Planning and Urban Design

To: City Planning Commission

Re: **Change of Zone Petition #3236, Urban Outfitters FC Preliminary Plat and #MP-2020-7**

SHEET TITLE
PRELIMINARY
GRADING PLAN

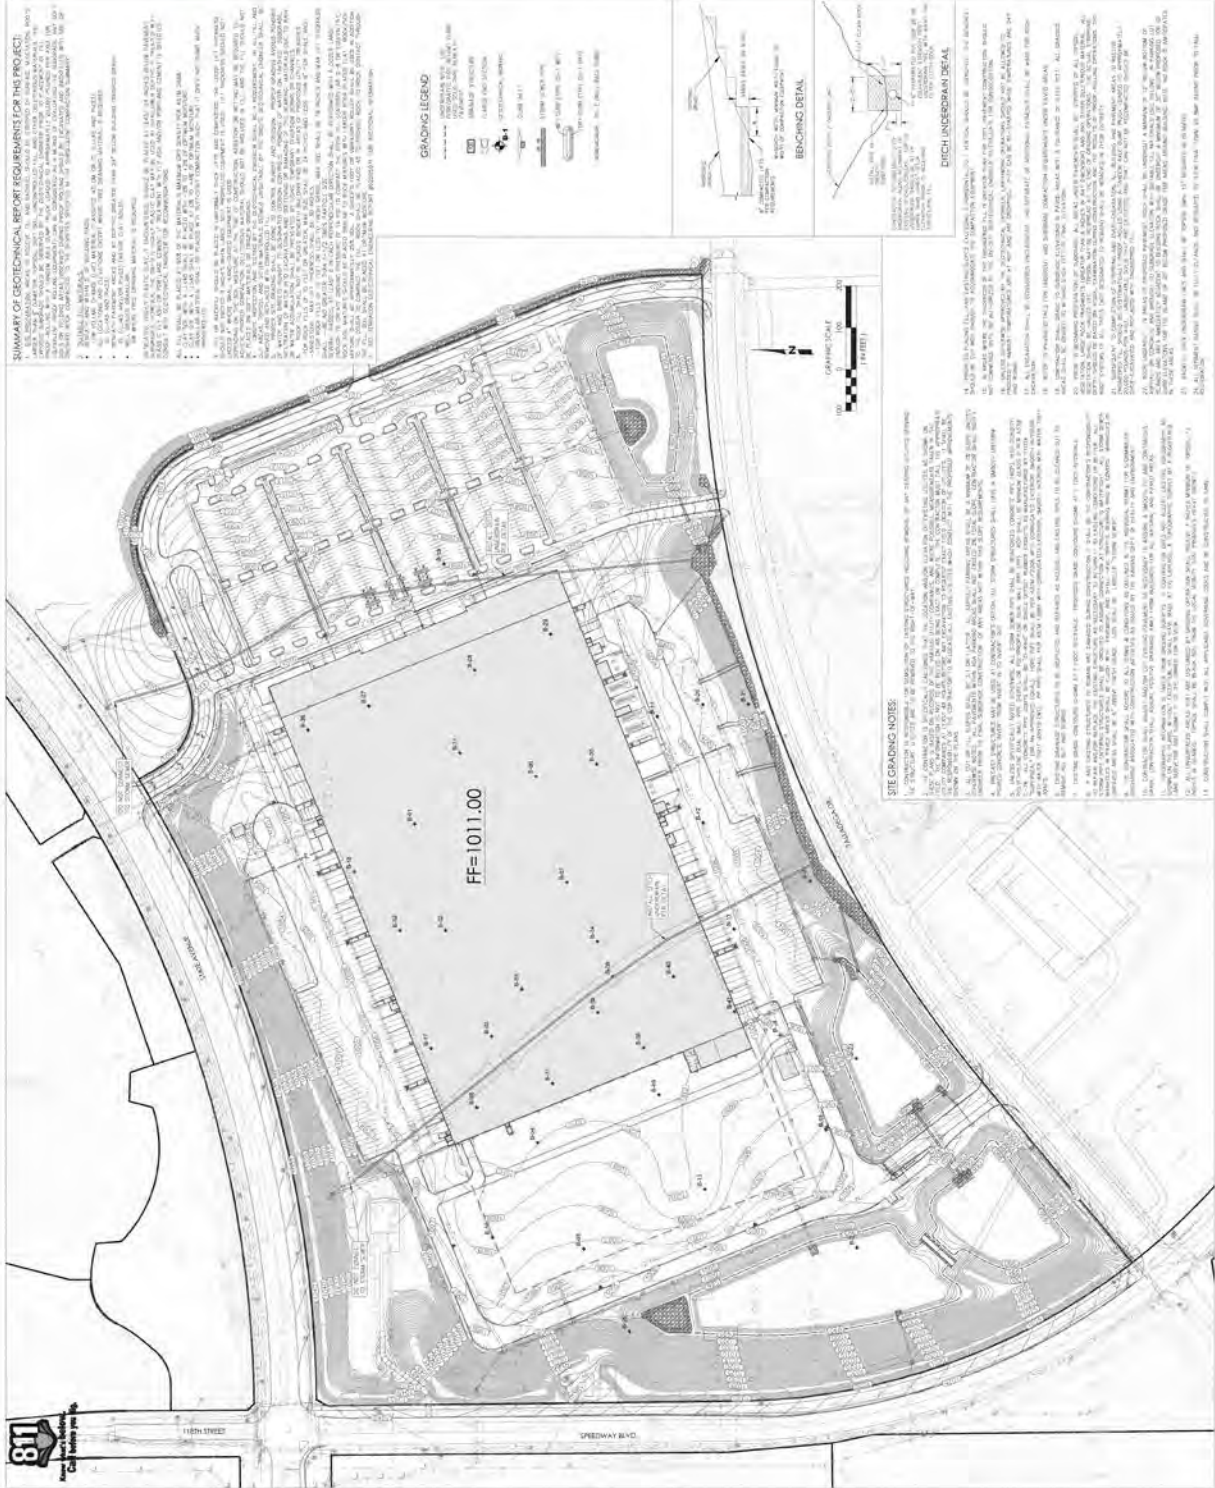
- 1) *As discussed with UG staff on 09.14.2020, please revise the plans to indicate construction entrance on Talladega Drive. Remove the construction entrance proposed on State Avenue. **The State Avenue construction entrance has been removed from the plans.***

- 2) *Proposed grading work outside the project boundary shall require construction easement(s). **Understood.***
- 3) *All items used in the erosion control plan that have a Standard UG Detail, shall be referred to by the standard UG Detail Number in the written erosion control plan and the construction sequence. (See UG checklists, standards and criteria) **Understood.***

- 5) Engineered sloped shall not be steeper than 3:1 Also, verify retaining walls are not proposed with the development. **Understood.**
- 6) See Erosion Control review comments. See sections above.

PRELIMINARY SITE LIGHTING PHOTOMETRIC PLAN

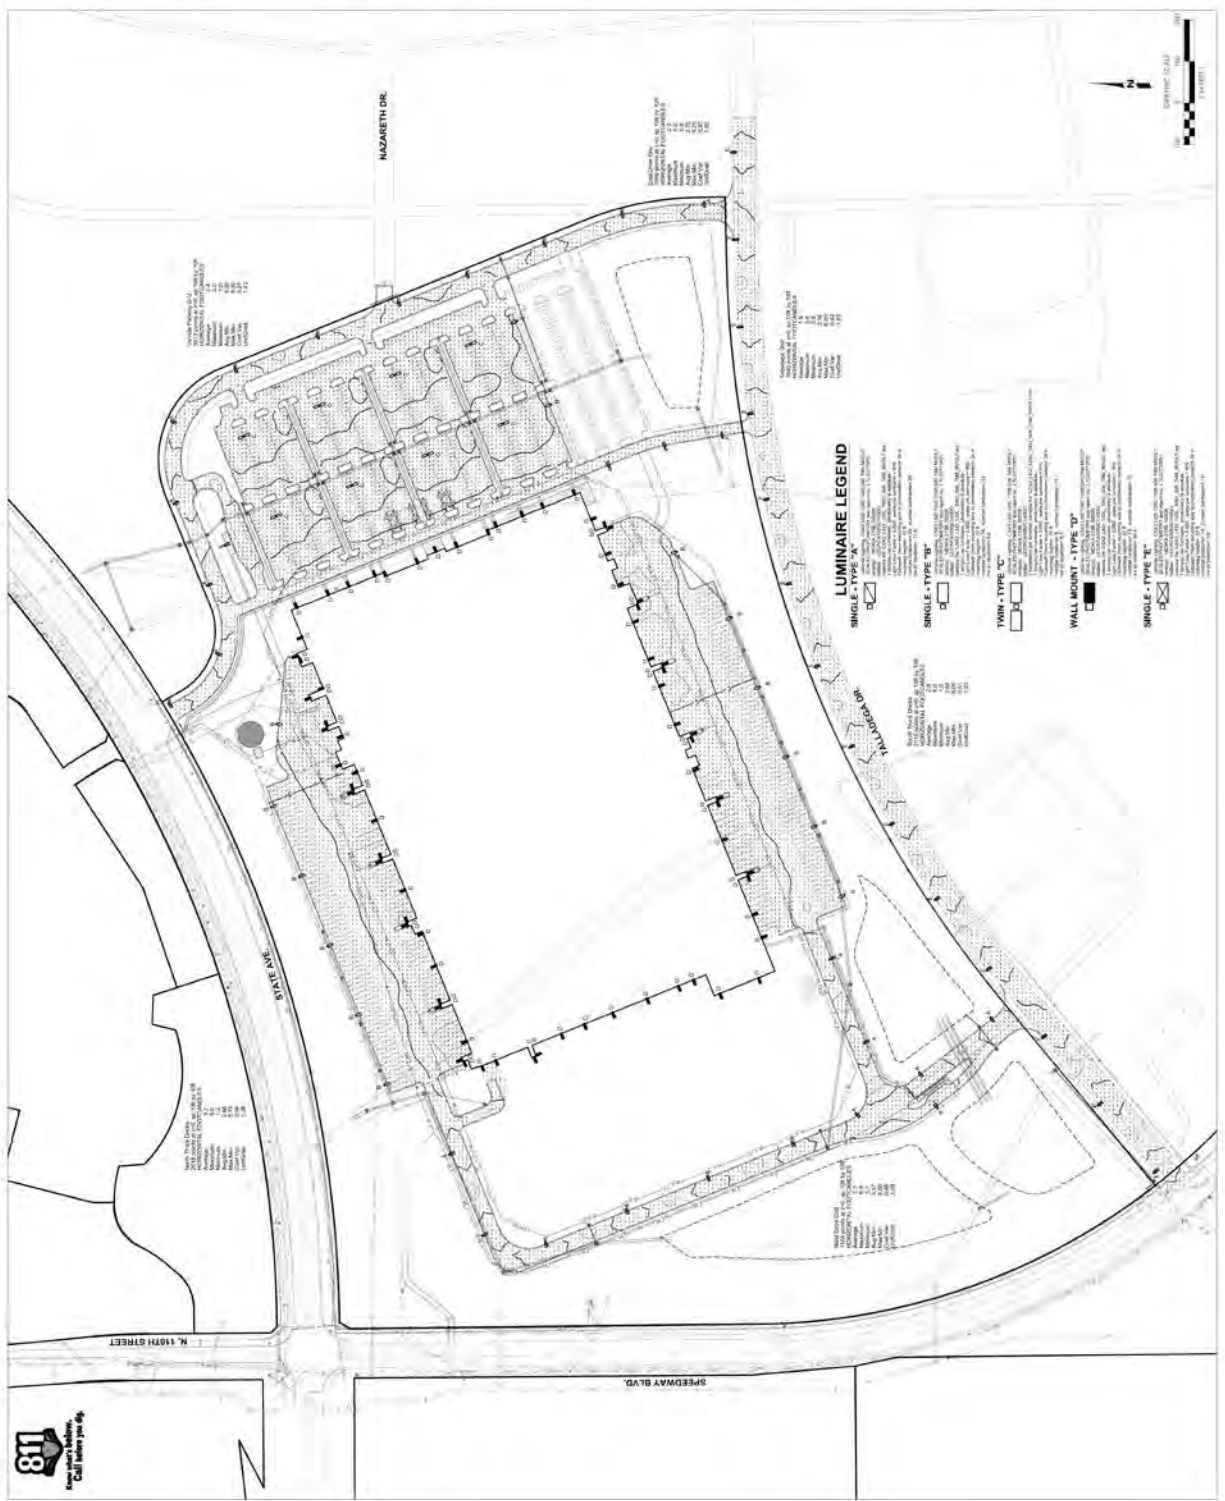
13. All lighting whether mounted on the building or installed in the parking lot shall have 90-degree cutoff fixtures. A Temporary Certificate of Occupancy to occupy the building will not be issued by Planning staff until this is accomplished.

Applicant Response: All lighting is full cut off with zero footcandles at the lot line, see the lighting details and photometric plans.
